## PRODUCT CHANGE NOTIFICATION (PCN)

### A-MCSP60030 MODULAR CABLE

PCN 20220822\_A-MCSP60030

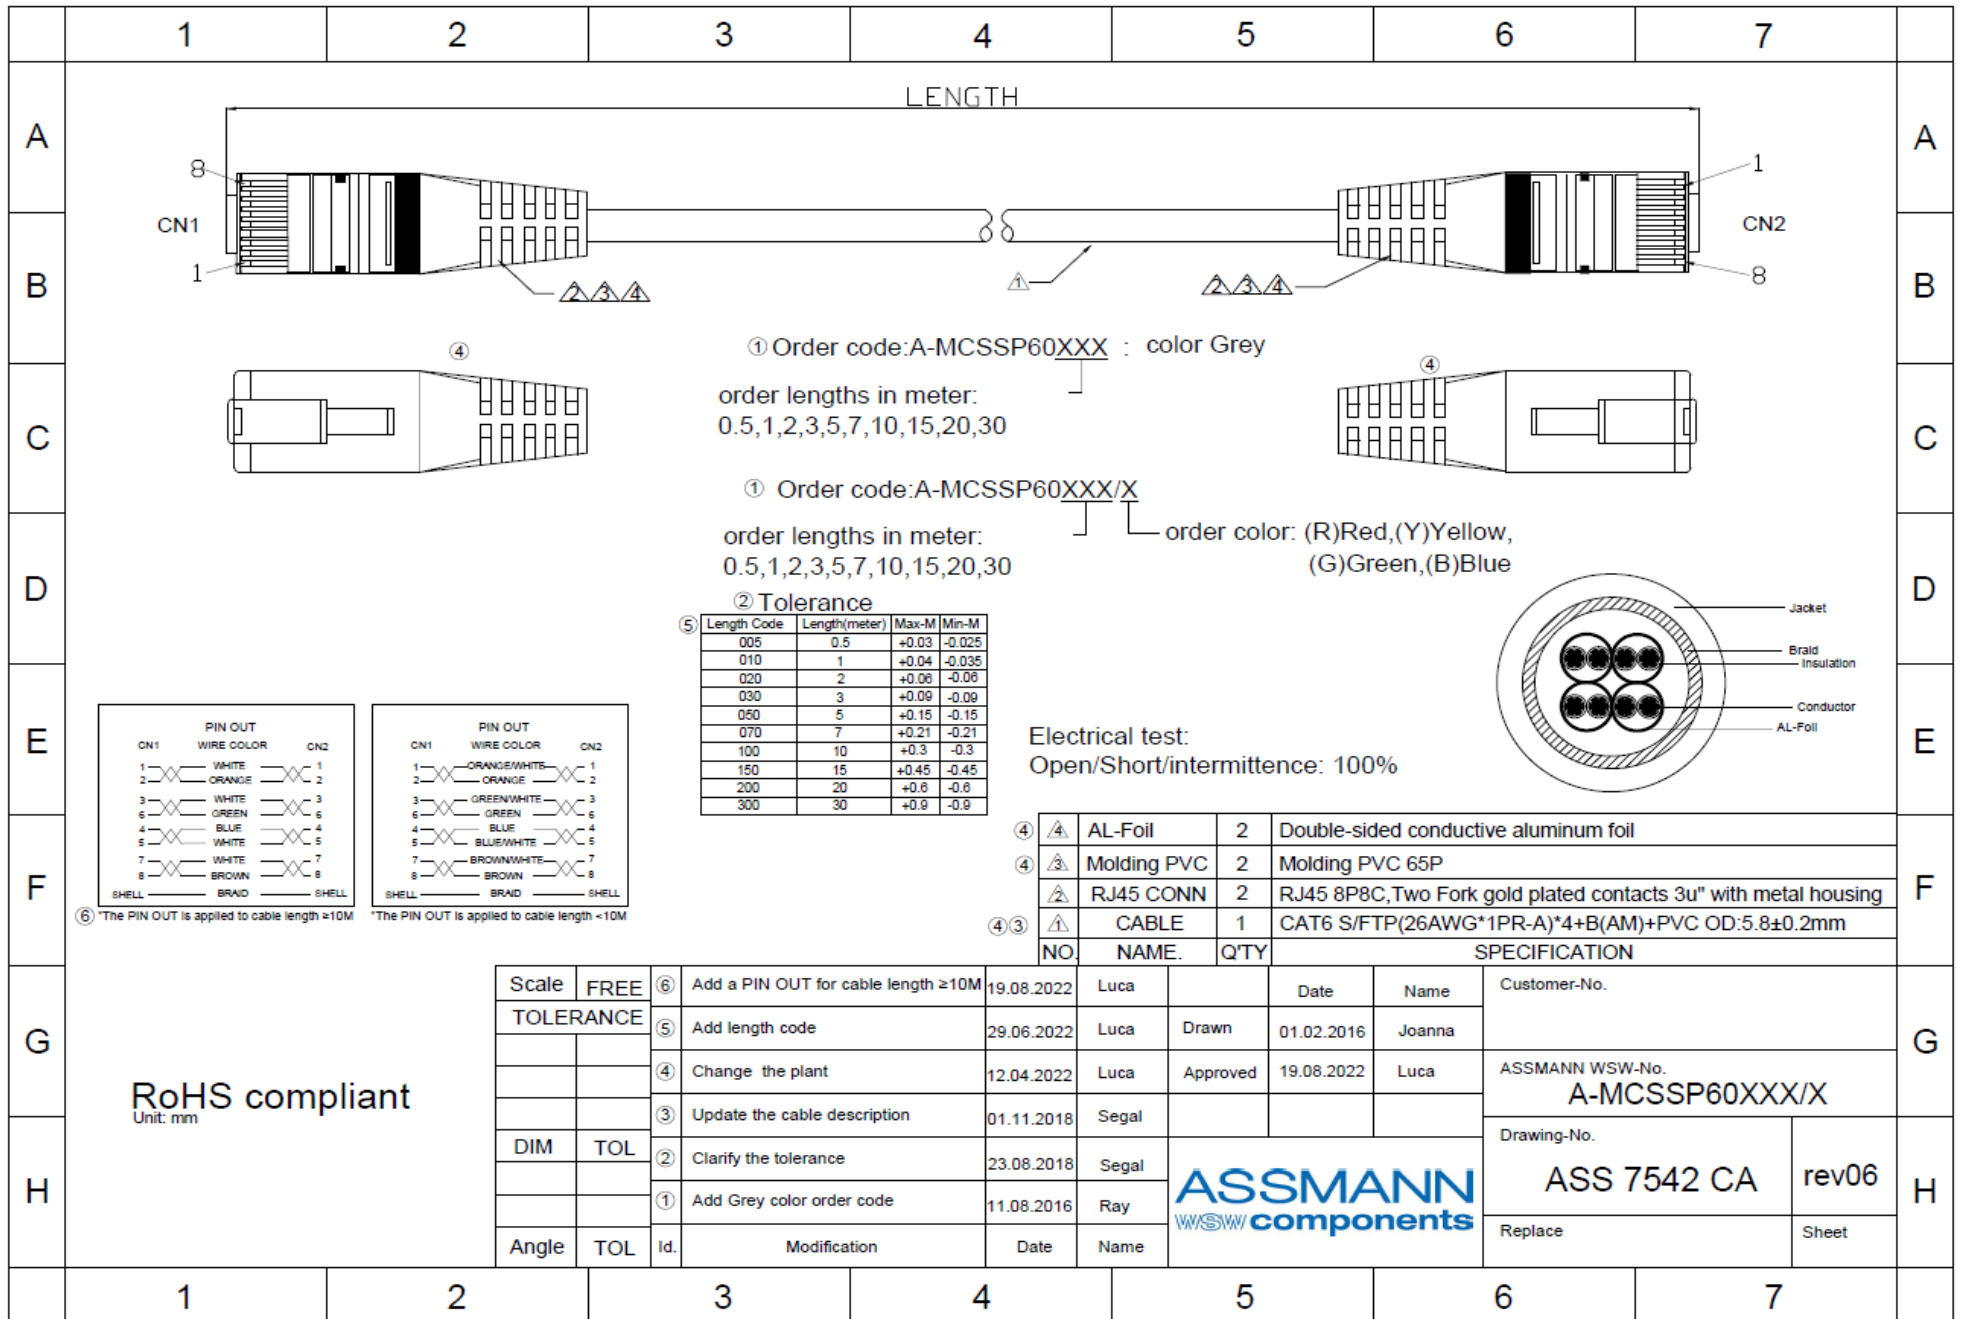
CHANGE OF DATA SHEET  
CHANGE OF DATA SHEET  
New Draw.-No. ASS\_7542\_CAreV06

CHANGE OF MATERIAL PARAMETERS OR PROPERTIES  
CHANGE OF MATERIAL PARAMETERS OR PROPERTIES

8	—	BROWN	—	8																																																																																																																																																															
SHELL		BRAID	SHELL																																																																																																																																																																
FOR DETAIL, PLEASE TAKE ATTACHED NEW DRAWING: FOR REFERENCE

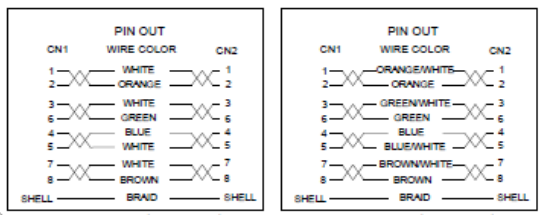
⑥ \*The PIN OUT is applied to cable length ≥10M \*The PIN OUT is applied to cable length <10M

Scale	FREE	⑥	Add a PIN OUT for cable length ≥10M	19.08.2022	Luca		Date	Name	Customer-No.
TOLERANCE		⑤	Add length code	29.06.2022	Luca	Drawn	01.02.2016	Joanna	ASSMANN WSW-No. <b>A-MCSSP60XXX/X</b>
		④	Change the plant	12.04.2022	Luca	Approved	19.08.2022	Luca	
		③	Update the cable description	01.11.2018	Segal				
DIM		TOL	②	Clarify the tolerance	23.08.2018	Segal			
			①	Add Grey color order code	11.08.2016	Ray			
Angle		TOL	Id.	Modification	Date	Name	Replace	Sheet	H
